Access Compliance Report Public Rights-of-Way (Curb Ramps)

Main Street: BLUME_DR Cross Street: TUCKER_LN Location: SW

ADA ID: RPRK211208132420 Ramp Type: Type 1 - Perpendicular Diagonal Initial Pass/Fail: Pass Overall Compliance: No Severity Score: 10

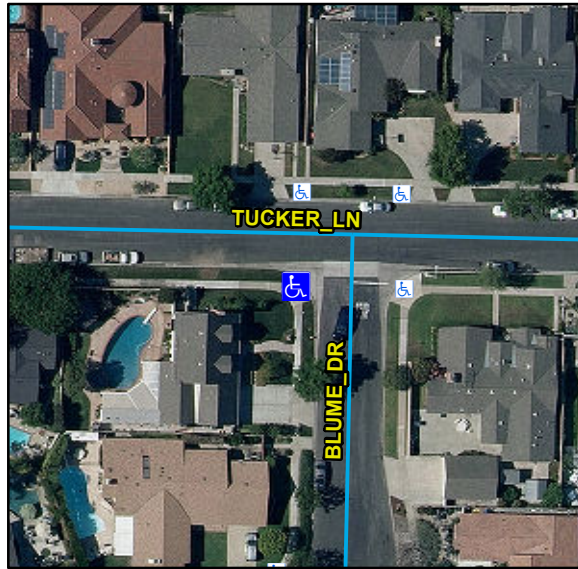
R204.3, R304.5.3, R305, STD 1115

Remove & Replace Curb Ramp With Two New Directional Ramps or Equivalent.
